PROJECT NAME:	NEWFANE	PLOT DATE:	22-OCT-2012
PROJECT NUMBER:	BRF 0106 (3)S	DRAWN BY:	C. MOONEY
FILE NAME:	s95j280xs.dgn	CHECKED BY:	G. SWEENEY
PROJECT MANAGER:	C. CARLSON	ROADWAY CROSS SECTIONS I	SHEET 47 OF 70
DESIGNED BY:	T. LACKEY

40 TYPE IV  
 40 TYPE IV  
 75 TYPE II

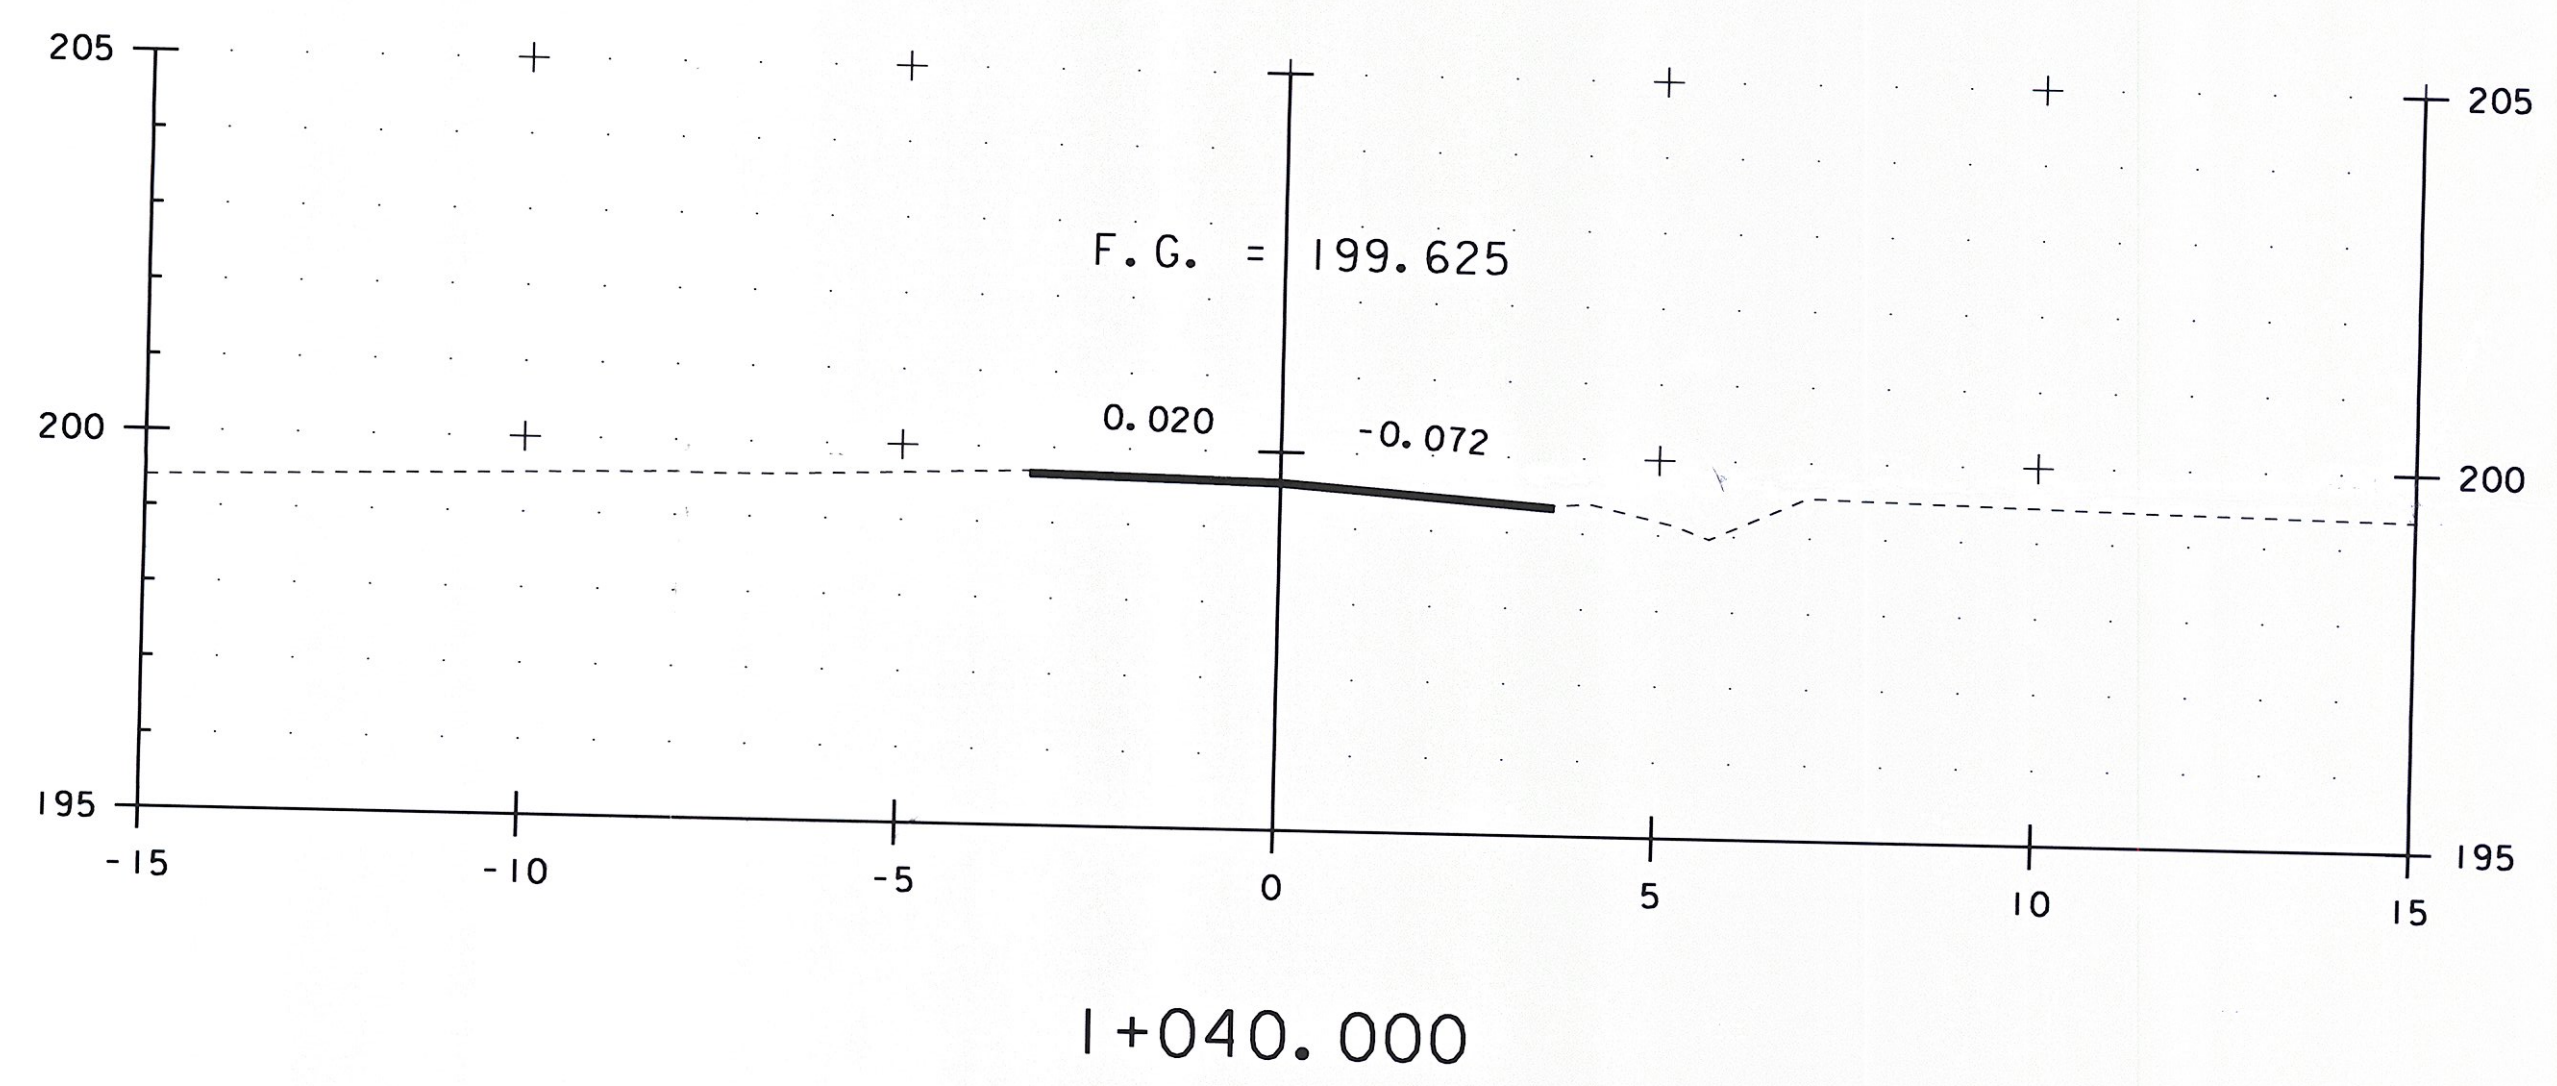
\* ADD 25 mm x width of cut to common excavation to account for added pavement depth.  
 Dense grade and sand stay the same
